CRYSTAL RIVER UNIT 3

**AREVA DOCUMENT ANP-3156(NP) – CRYSTAL RIVER 3 EPU
BORIC ACID PRECIPITATION RAI RESPONSES
(NON-PROPRIETARY)**

Crystal River 3 EPU
Boric Acid Precipitation RAI Responses

September 2012

Figure 3: Boron Solubility Limits versus Core Fluid Temperature

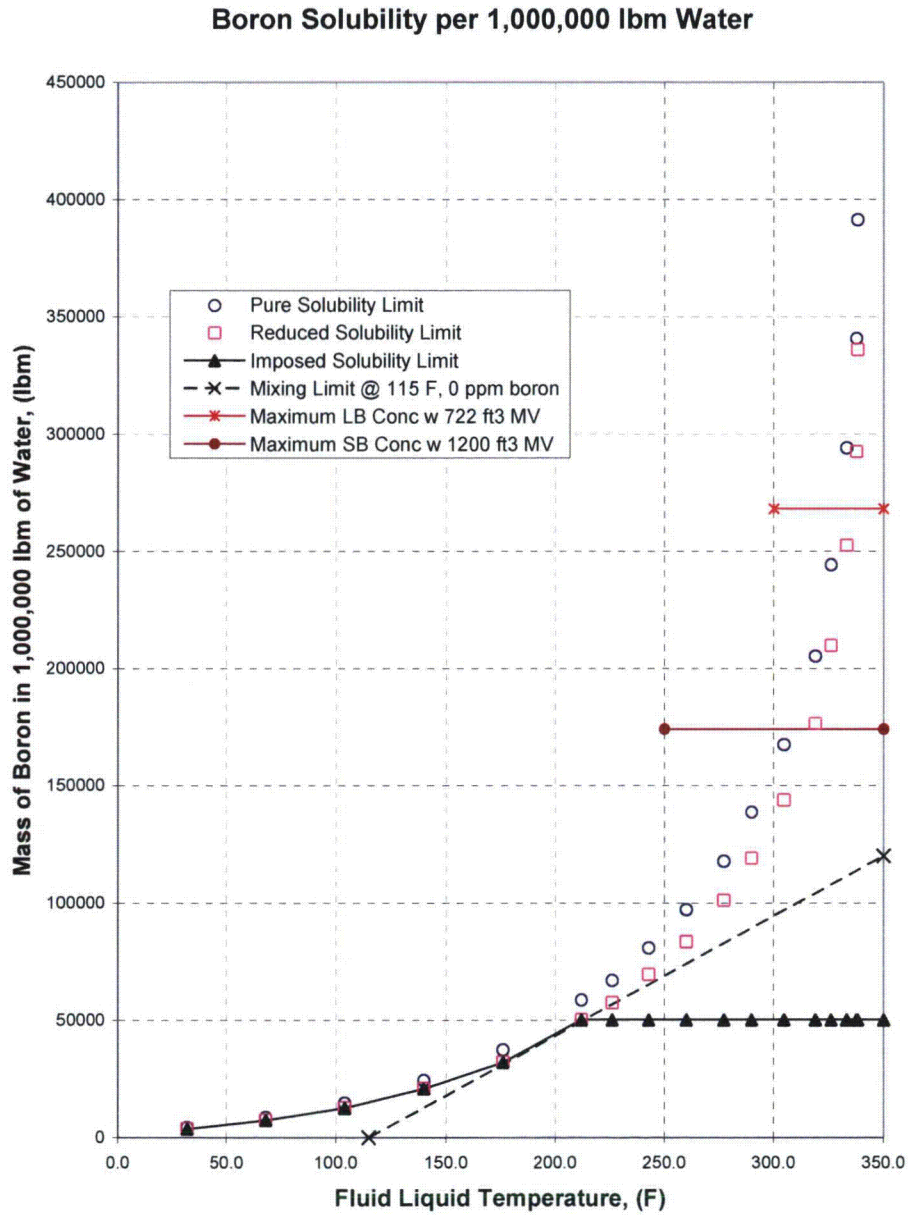
SNPB 2-2: What is the sump temperature versus time following recirculation initiation and how does this impact precipitation? Is the boric acid concentration in the vessel below the precipitation limit based on the minimum sump temperature at the time the switch to simultaneous injection is performed? Please explain.

Figure 3 provides an example in which 115 F water with a zero boron concentration is injected into the hot leg following HLI initiation. The mixing limit for this fluid temperature is the line that goes through this temperature and is tangent to the reduced solubility limit, which is the pure boric acid solubility limit reduced by the fractional equivalent of 4 w% H_3BO_3 . In this case, the mixing limit is more restrictive for temperatures less than 212 F. At higher temperatures, the constant solubility limit equivalent to that for a saturated mixture at 212 F, which is imposed in the CR-3 EPU BAP analyses, is more limiting than the mixing limit. The minimum of the mixing limit in the hot leg or lower plenum and the constant saturated solubility limit in the core determines when an active dilution method is needed. The saturated solubility limit prevents precipitation in the core. The mixing limits prevent precipitation in the hot leg or the lower plenum regions.

Also shown on Figure 3 are the core concentrations based on putting all available boron mass (BWST, RCS, CFT, and BAST injection) in the core region with a minimum LBLOCA core mixing volume of 722 ft³. A similar concentration calculation was performed for the SBLOCA core mixing volume of 1200 ft³ and it is also shown on the figure. These two lines represent the maximum core concentration that the core could achieve after several weeks of core boiling without any active or passive boron dilution methods providing boron dilution.

Figure 4: LBLOCA Core Boric Acid Concentration versus Time.

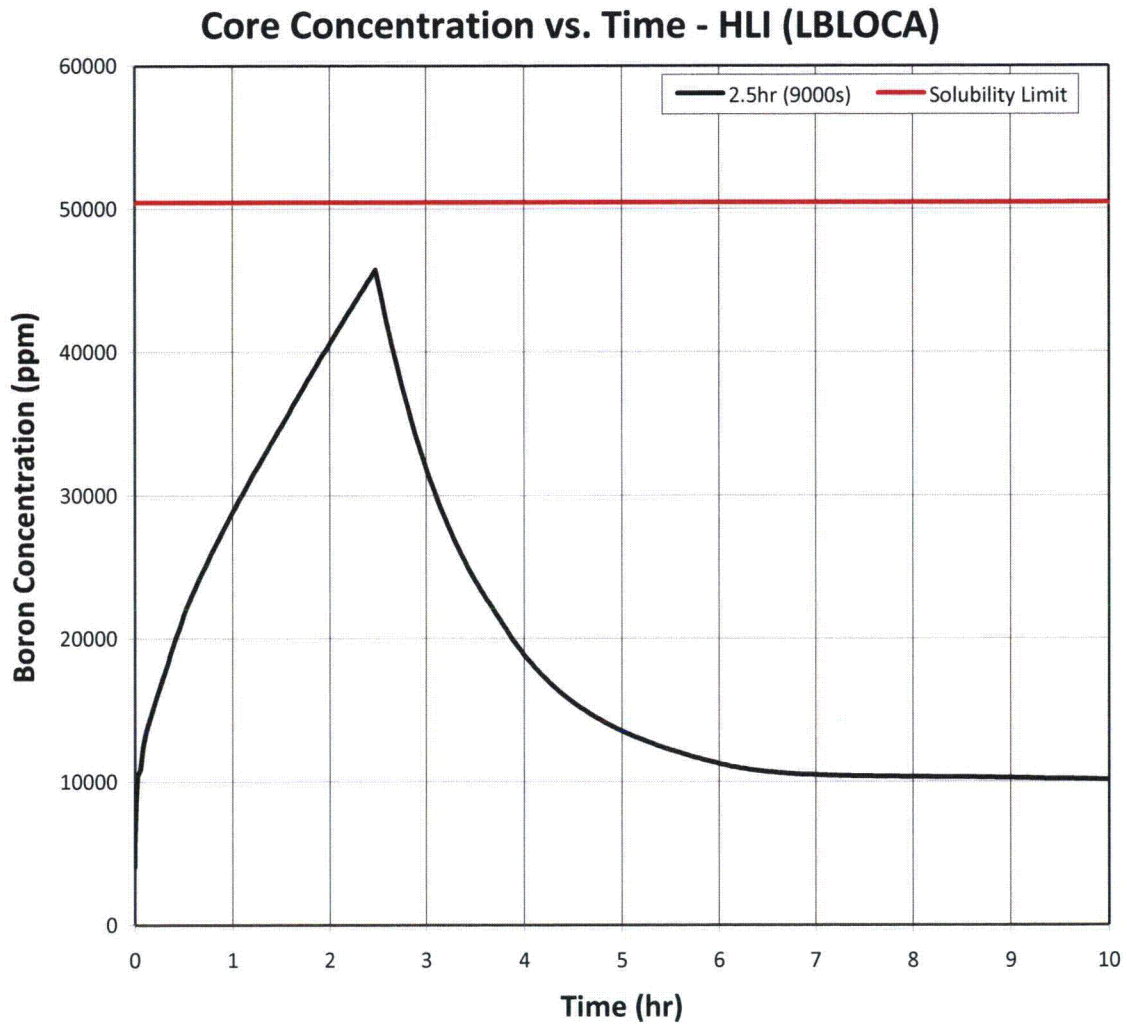
SNPB 2-5: Please provide the boric acid concentration vs time for the limiting large break loss-of-coolant (LBLOCA) and the limiting SBLOCA?

A spectrum of nine different break sizes has been considered and boron concentrations versus time and long-term RCS pressure response were calculated for each. With the assumption of no RVVV liquid overflow or hot leg nozzle gap flows, the largest LBLOCA with the minimum pressure will have the lowest core mixing volume and get to the solubility limit sooner. This case is described as the limiting LBLOCA case and its concentration is provided in Figure 4. It has an RCS pressure of 14.7 psia and core mixing volume near the time of peak core concentration of 722 ft³. As break sizes decrease, the RCS pressure increases, as do the core mixing volume and the solubility limit. However, no credit is taken for the increase in the solubility limit versus saturation temperature, so the core concentration predictions during the transient are lower only because the core mixing volume increases with pressure. The imposed constant solubility limit used on smaller break sizes with core mixing volumes (that may be near or at a capped maximum value of 1200 ft³) results in similar core concentrations for these SBLOCA cases. These considerations make it difficult to define the limiting SBLOCA. However, the RAI asks for the limiting SBLOCA so it is characterized as the case with an RCS pressure that will not use HLI to actively control the core boron concentration. The pressure for this case is an uncertainty adjusted minimum coinciding with an indicated 140 psia maximum pressure that HLI can be used to mitigate. The maximum pressure uncertainty is roughly 70 psid, so an RCS pressure could be anywhere between roughly 70 and 140 psia. An RCS pressure of 71 psia (just above the minimum uncertainty value) was selected because it has the smallest core mixing volume for cases in this pressure range. Figure 5 provides the core boron concentration for a 71 psia SBLOCA that credits operator action to open the HL-BD at 4.5 hours. A mixing volume of 1011 ft³ was used with a conservatively low flow of 50 gpm of out of the hot leg injection blowdown line after 4.5 hours.
